WORLD WAR II MEMORIAL
Rainbow Pool, West Potomac Park, 17TH Street, NW.,
Between Independence and Constitution Avenues

Report to the National Park Service and the American Battle Monuments Commission

June 3, 1999

ROADWAY ALTERATIONS
SCALE: 1:500

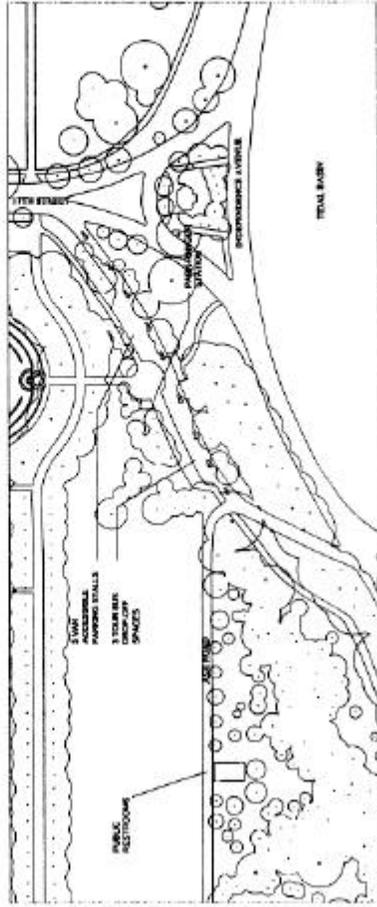
The proposed roadway changes will reduce open space on the Independence Avenue side. In addition, the traffic revisions on the north at Constitution Avenue will introduce elements somewhat out of character with the south side of Constitution Avenue. However, the new curb cuts will be offset by the removal of the existing Tourmobile road along Constitution Avenue and will return that total area to green space.

SACRED PRECINCT
SCALE: 1/8" = 1'-0"

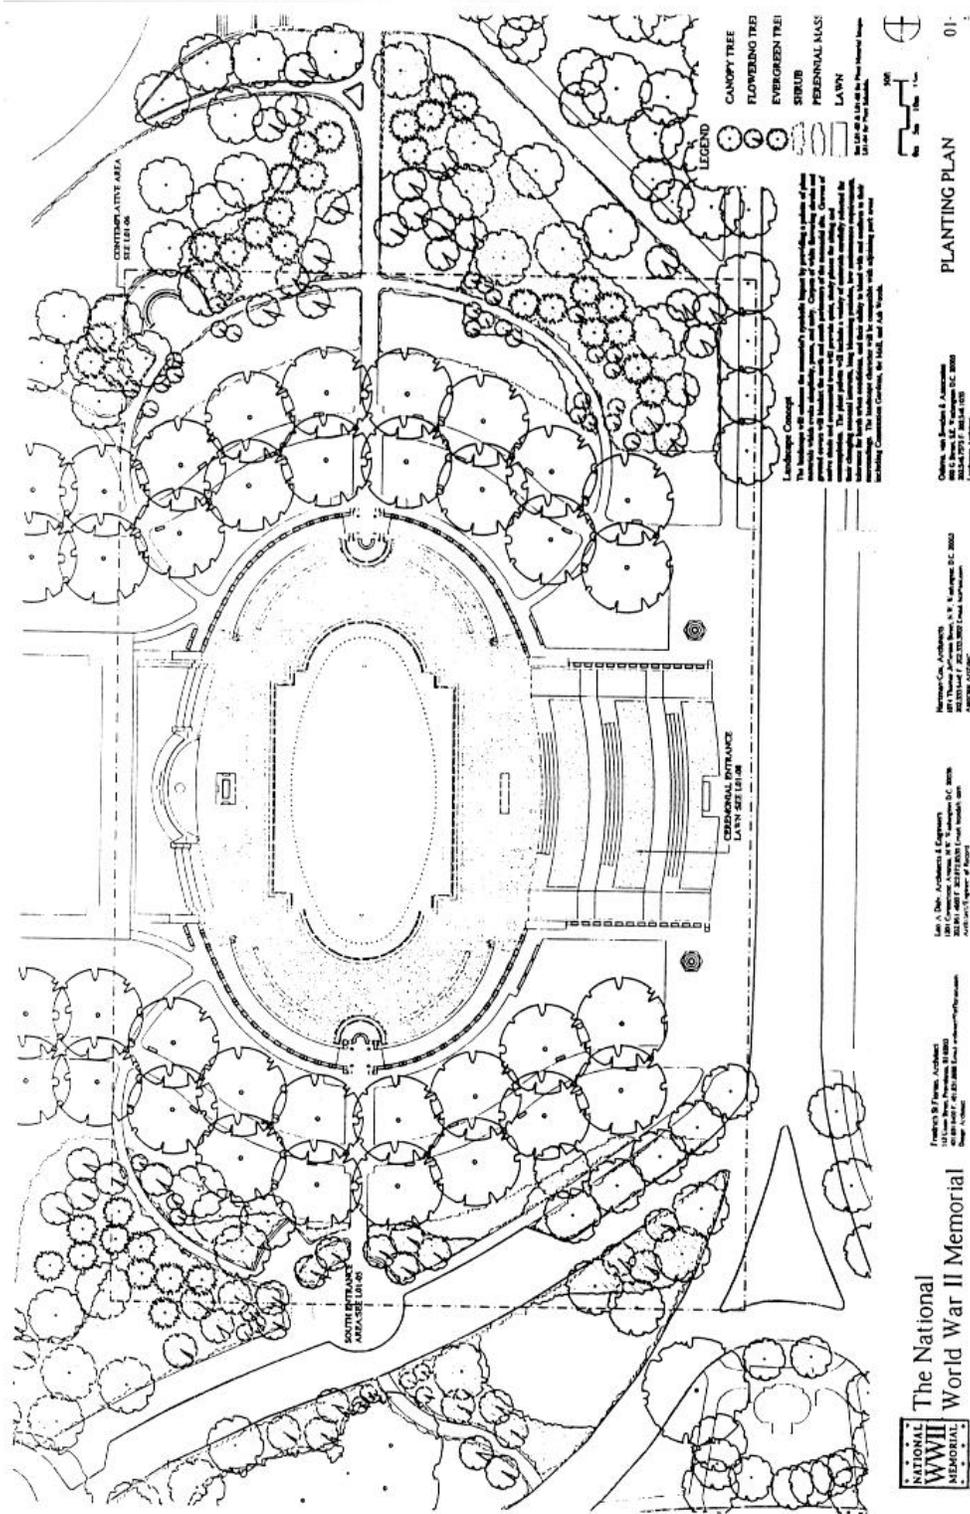
Although the sacred precinct area is more clearly defined with elements such as wreaths, the cenotaph, and the broken plane with a flame/sculpture element, this area still needs additional design. Specifically, the form of the flame/sculpture element and the texture of the broken plane element representing the upheaval of war.

- Continue to explore methods of incorporating plant material into the memorial plaza in a manner that will not require bollards and chains for maintenance purposes.
- The Commission looks forward to the clarification of the forms of the flame/sculpture and the broken plane elements during the design development of the Sacred Precinct area.

PLANTING PLAN 01

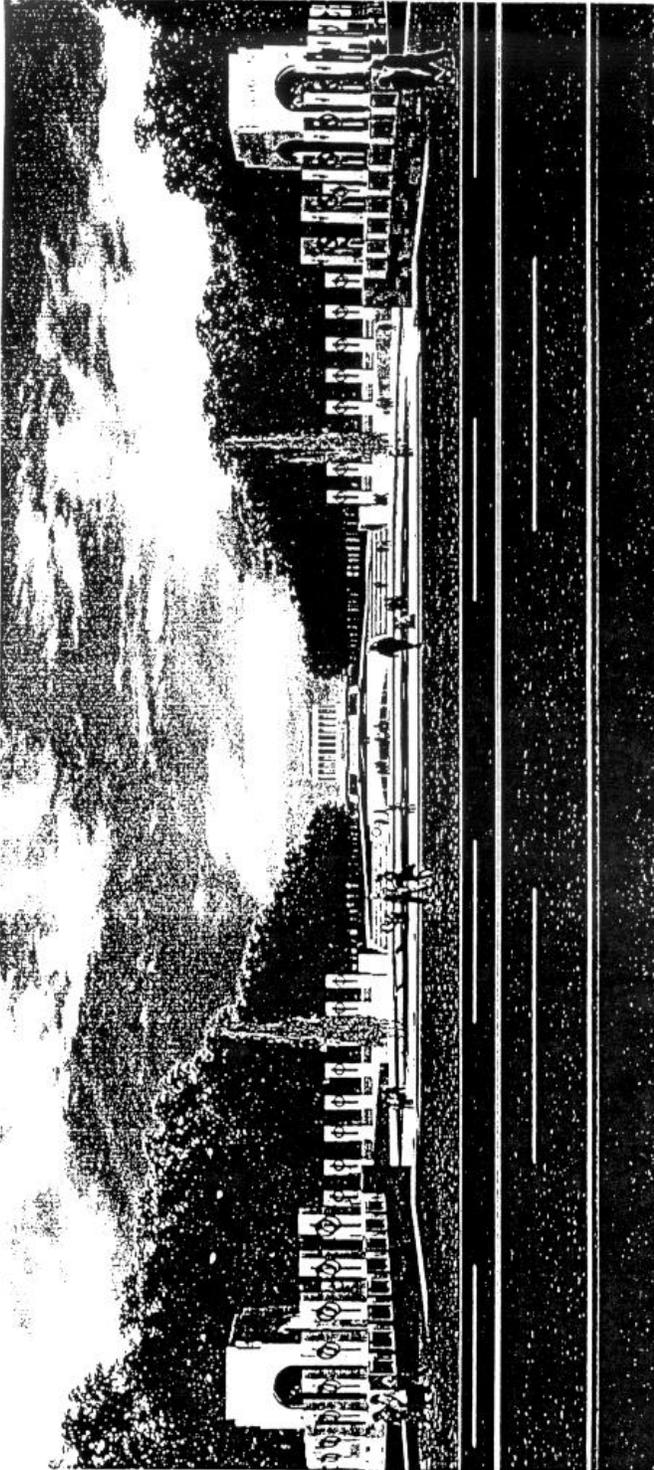
The landscape treatment is now more defined. Textured and nontextured areas are clearly delineated and incorporated with pedestrian pathways within the memorial site. Although landscaping proposals are clearly indicated within the site, there are proposals for new plantings outside of the site boundaries. Specifically, the planting plan shows new plantings north of the site up to the existing terrace at the East End of Constitution Gardens. The design team should determine the extent of new off-site landscaping proposals as well as other improvements that are related to the WWII Memorial.

There is currently no proposal for incorporating plant material within the memorial plaza area. Although measures such as varying patterns and colors of granite paving are proposed to provide some form of visual relief from the expanse of paved surface, the ABMC and its design team should continue to explore methods of incorporating plant material into this area. Staff is confident that the design team can design-in landscaping that will not require NPS to erect chains and bollards for maintenance reasons.
